工程指示 / 要求簡箋(E.I.)

工程指示編號：EI / 2690/20

工程名稱：亞皆老街中電

工程項目：亞皆老街中電 回覆王良幕牆組裝問題(窗外蓋)

1 VERTICAL DETAIL  
6002

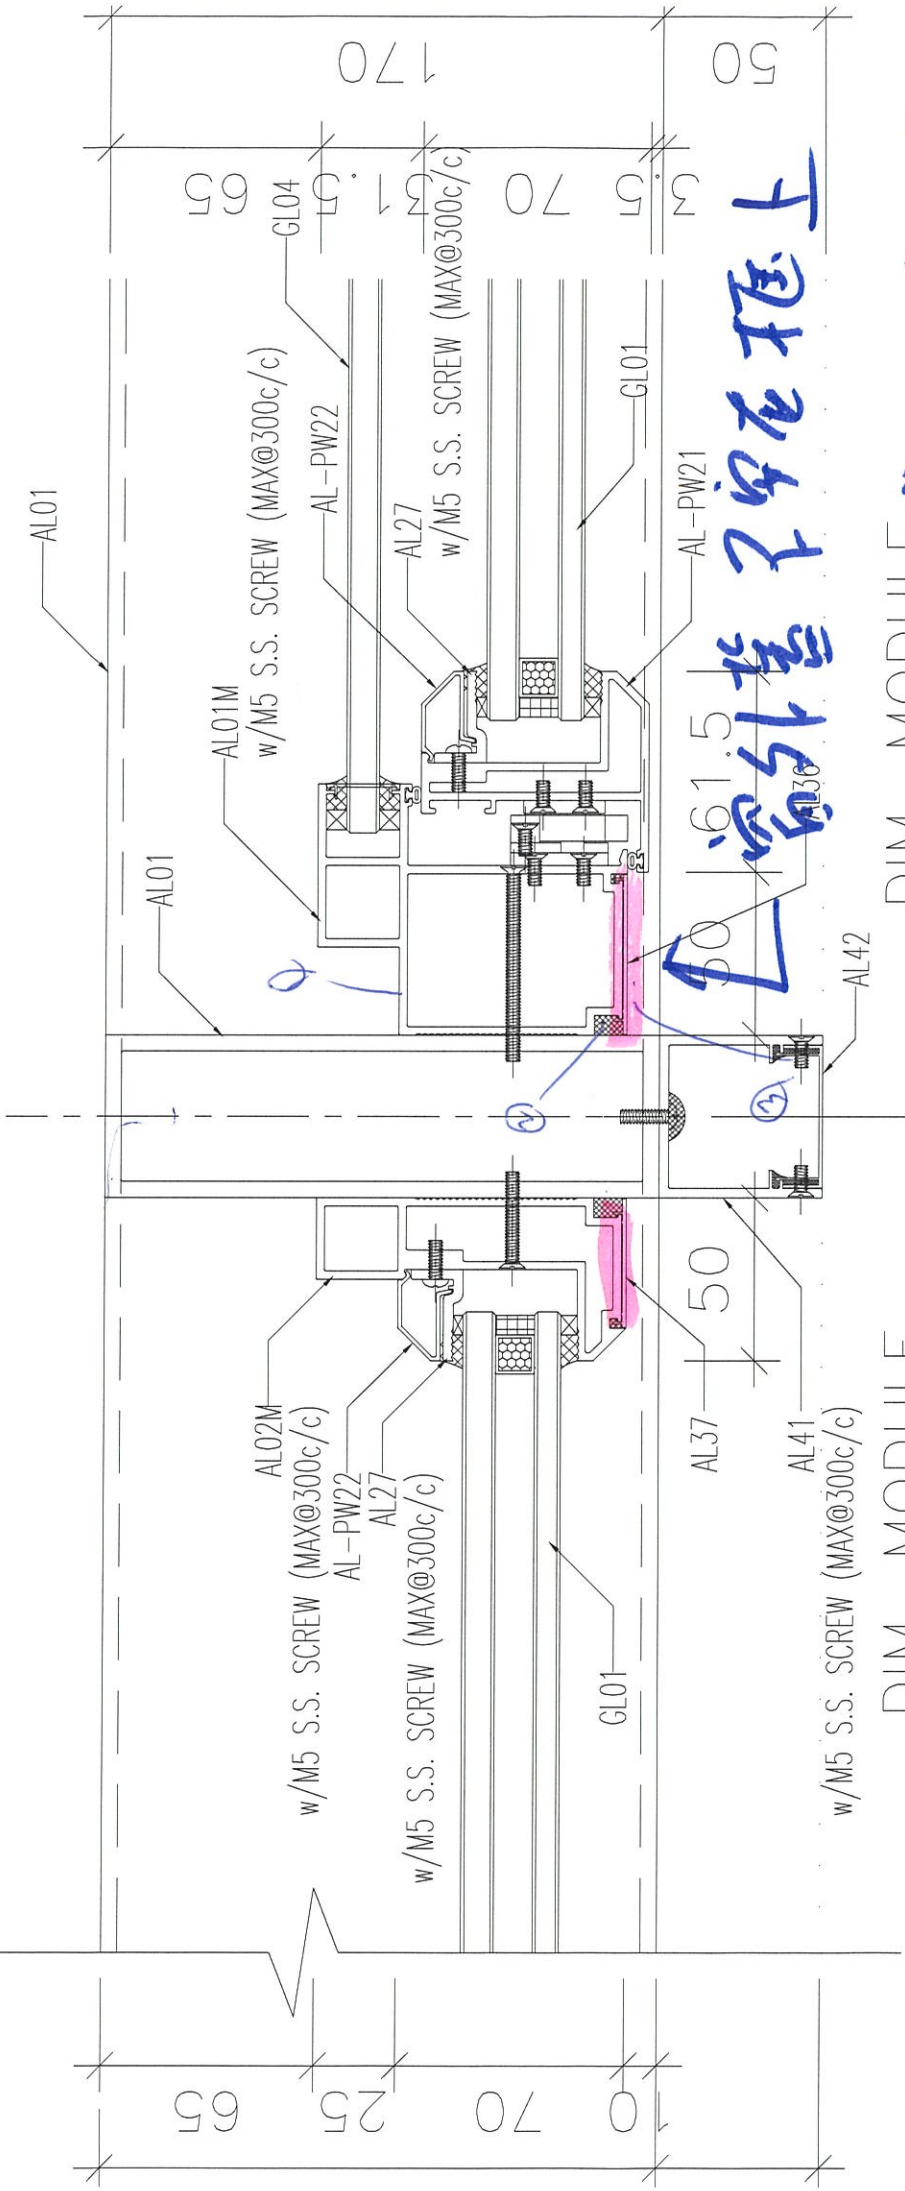
① 窗框在框上

和窗框一起出包，一起打包

出貨時，窗外蓋與窗框一同打緊，一起出貨，現場啣膠後裝 (與EI 2691相同)。

T1, T2, T3窗框室外蓋派位圖

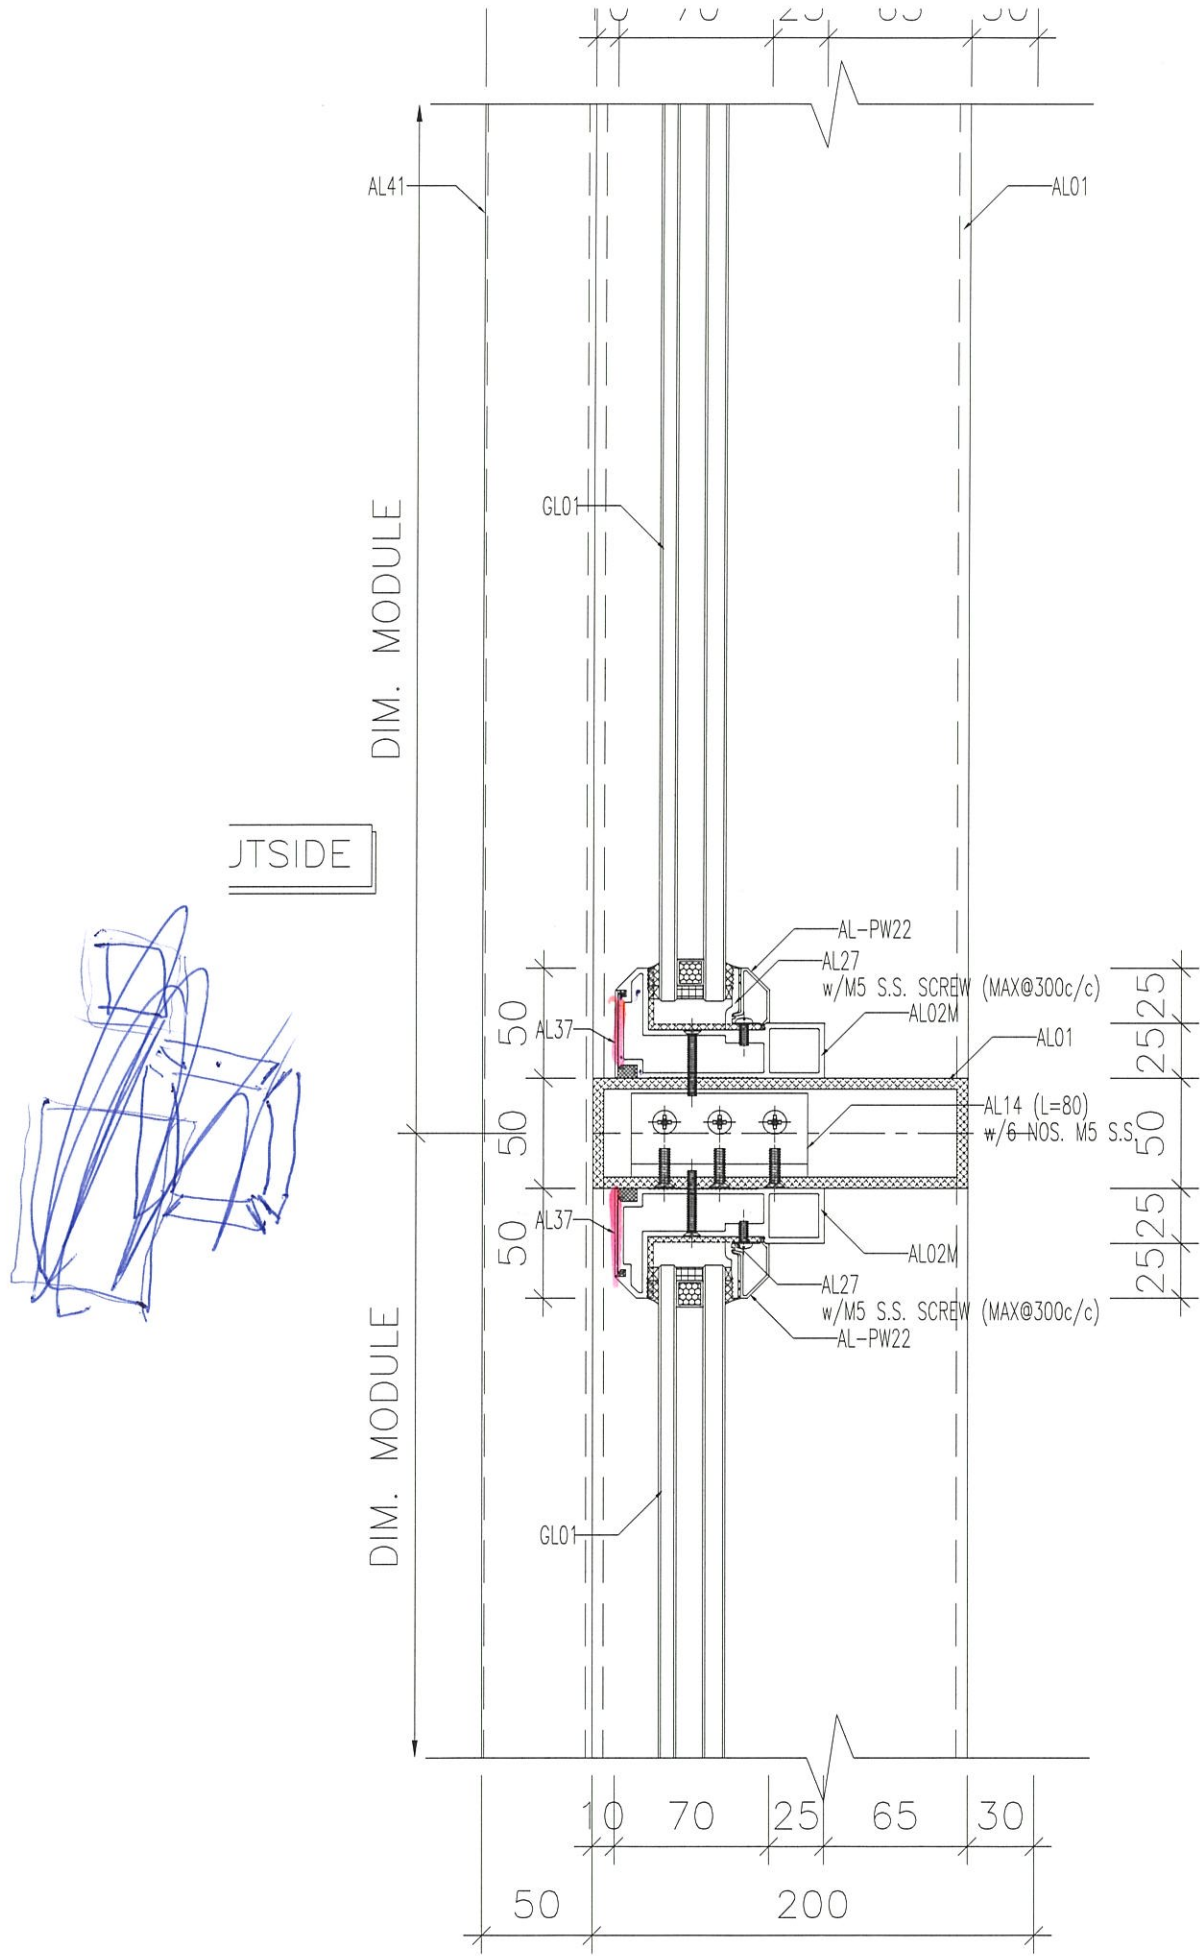
和窗框一起出包  
叫胶条包
